VICINITY MAP & GENERAL NOTES
Walker Rd./Jane Lundeen/Pinehurst
Signing and Striping Plan

JANE LUNDEEN DR. SIGNING AND STRIPING PLAN
Walker Rd./Jane Lundeen/Pinehurst
Signing and Striping Plan

PINEHURST DR. SIGNING AND STRIPING PLAN
Walker Rd./Jane Lundeen/Pinehurst
Signing and Striping Modifications Plan

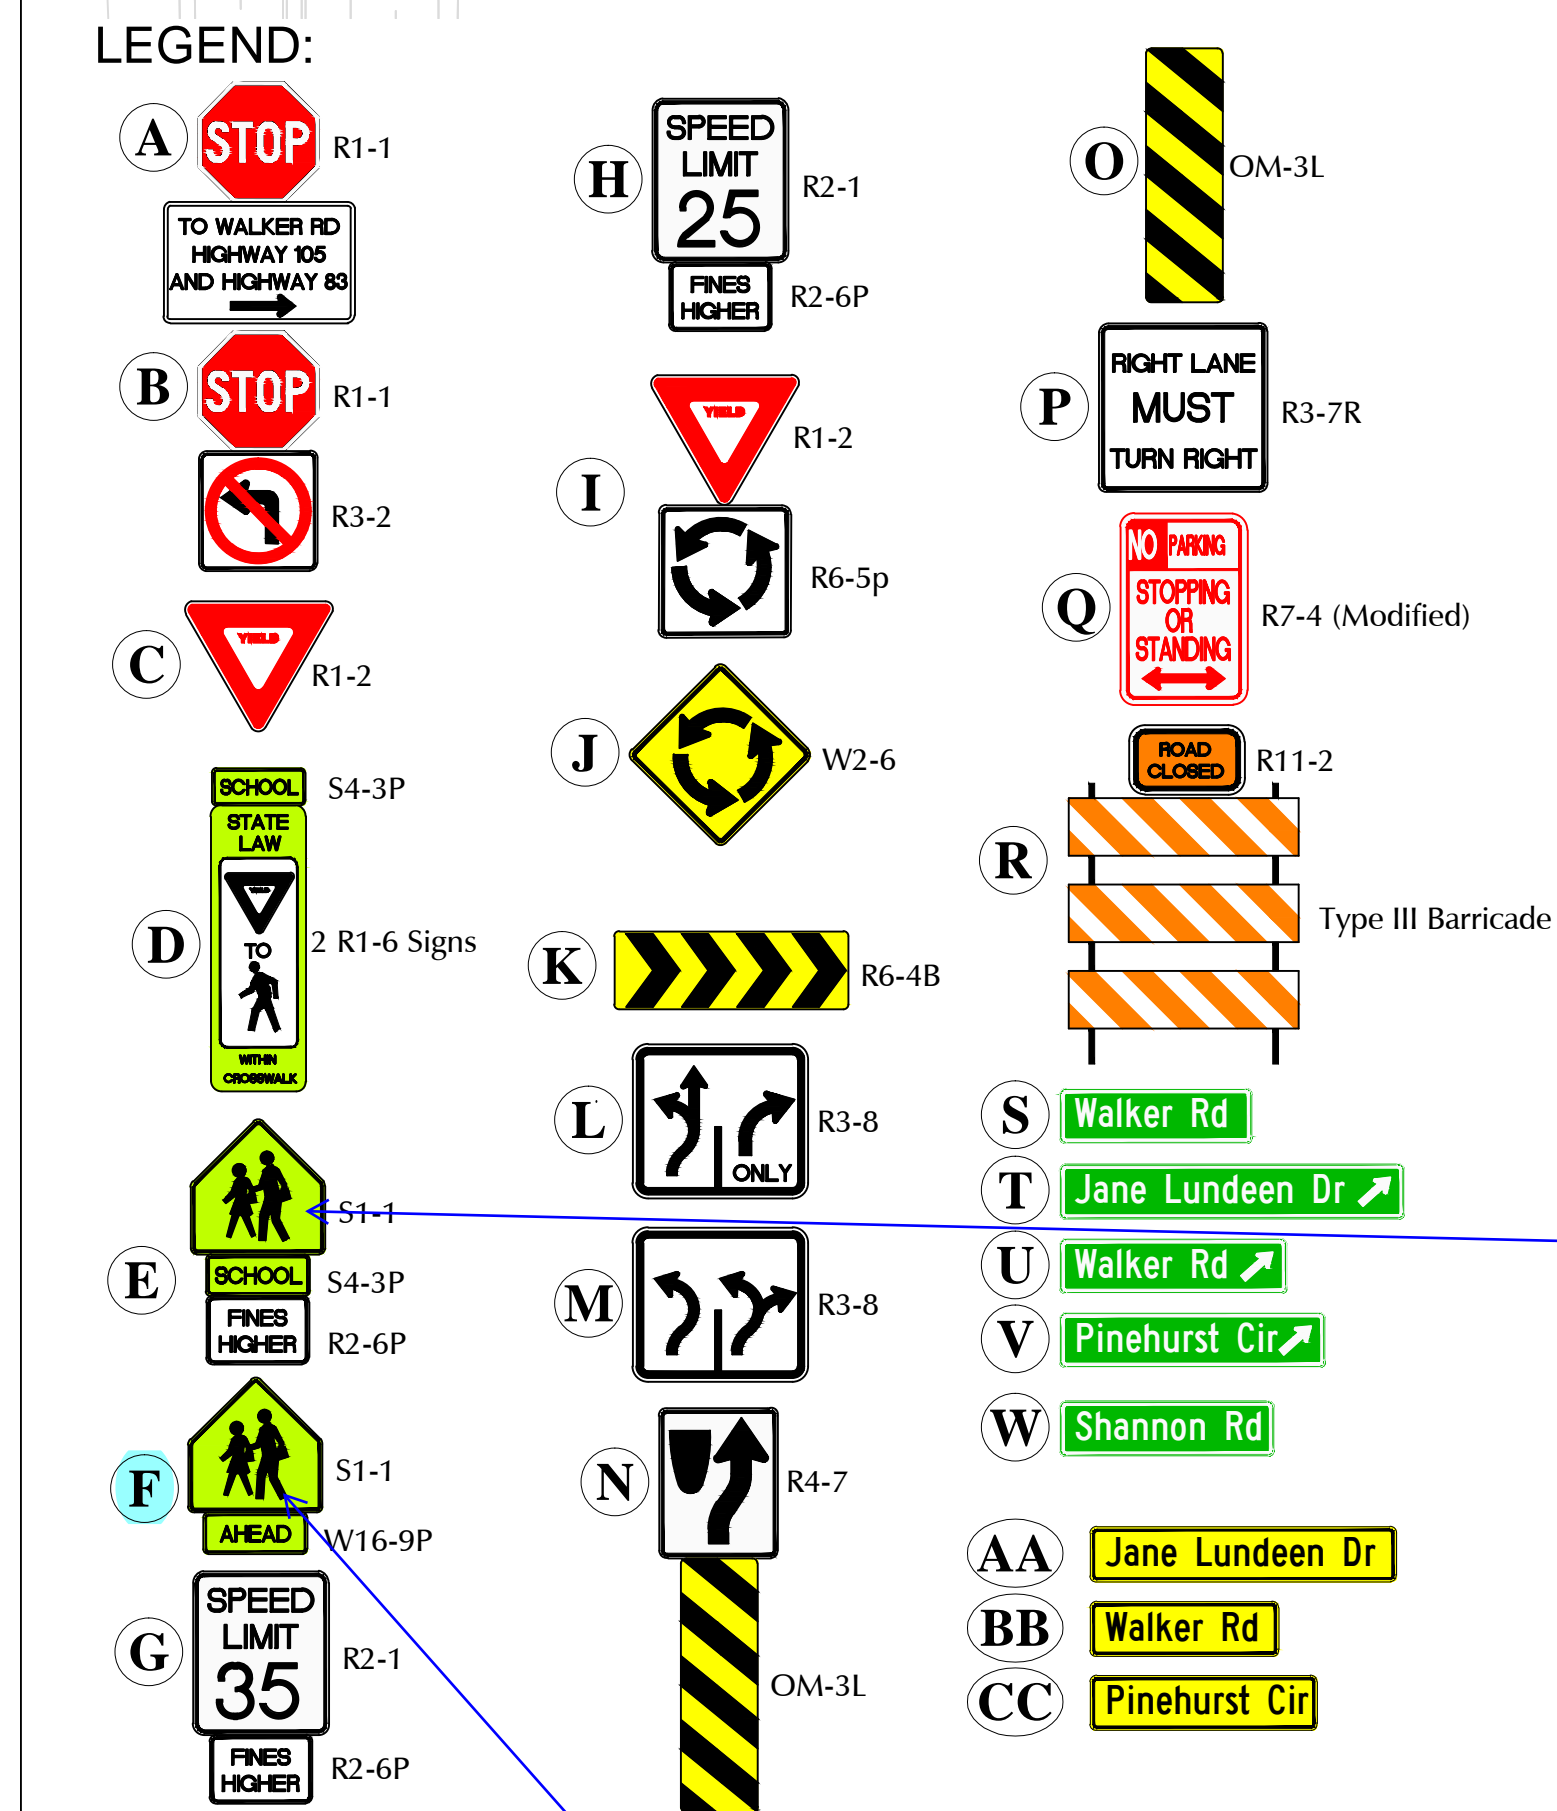
not used?

G?
